# **FINAL ARGUMENT OF THE PROTECT THE CHIGNECTO Isthmus COALITION**

**Matter EL-002-2025**

Application by NB Power for Approval of the  
Renewables Integration and Grid Security (RIGS) Capital Project  
Pursuant to Section 107 of the Electricity Act

February 19, 2026

Figure 4: LOLE Results – Base and All Sensitivity Cases

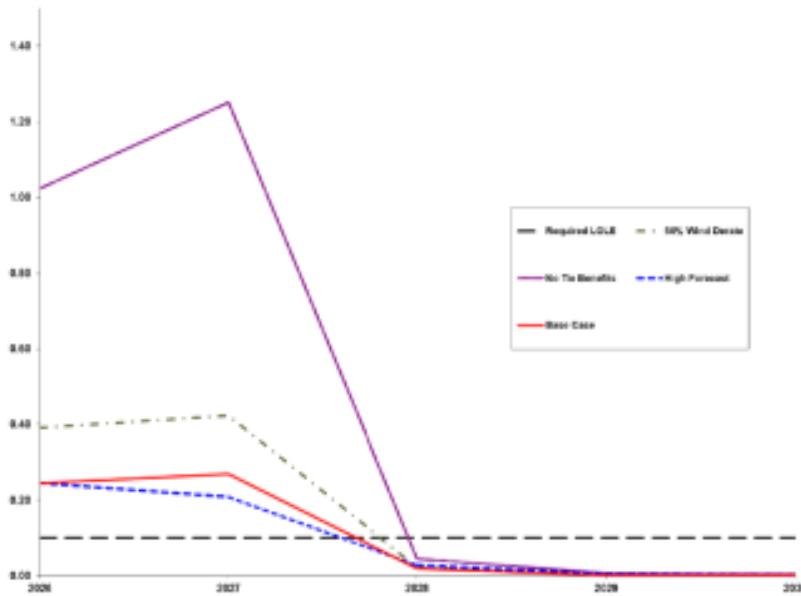
- **Timing and credibility:** The document is dated **October 2025**, i.e., **before** NB Power's pre-filed evidence deadline. NB Power **did not file it**, which raises a credibility concern (NBP 8.06 at p. 53).
- **Schedule reality:** It shows RIGS is **not online** by **Winter 2028**, but rather **Winter 2029**. This undermines the purported "urgency" that has driven **hundreds of millions of dollars** in additional costs to meet Winter 2028—costs that were "**all for nothing**."
- **Adequacy results:** The Maritimes **do not meet** LOLE criteria in **2026–2027**, but **easily meet** the standard in **2028 without RIGS**. Even using the **300 MW** No Interties sensitivity, the analysis shows **RIGS is not needed as far out as 2030**. LOLE (no tie benefits) on p. 43 is **0.045 days/year in 2028, 0.008 days/year in 2029**, and **0.004 days/year in 2030**.

**Capacity exports during a crunch.** It emerged on cross that one reason the Maritimes are not compliant in 2026–2027 is that NB Power has **capacity export contracts** in ISO-NE. When Board Staff asked Mr. Cody directly whether NB Power is **selling capacity in a capacity crunch**, he answered: "**Yes, that's correct.**" (Feb. 11, p. 61.) Mr. Pollock added that NB Power or its marketing affiliate would proceed with such commercial obligations "**if it's a net positive benefit for New Brunswickers.**" If NB Power's **financial risk management policies** allow selling capacity that New Brunswickers need, **those policies warrant review**. The sales affect the **Maritimes LOLE**—not just New Brunswick's—raising the question why, if our **neighbors** are also in a crunch, the capacity was not sold **within the Maritimes** instead. See NBP 8.06 at pp. 52–53: removal of a **122 MW** sale after May and addition of a **177 MW** sale starting June in NB. Although the panel noted these contracts "**unwind**" and should not affect winter capacity, **there is no proof** on the evidentiary record; what **is** on record is that they **do** affect the Maritimes LOLE results.
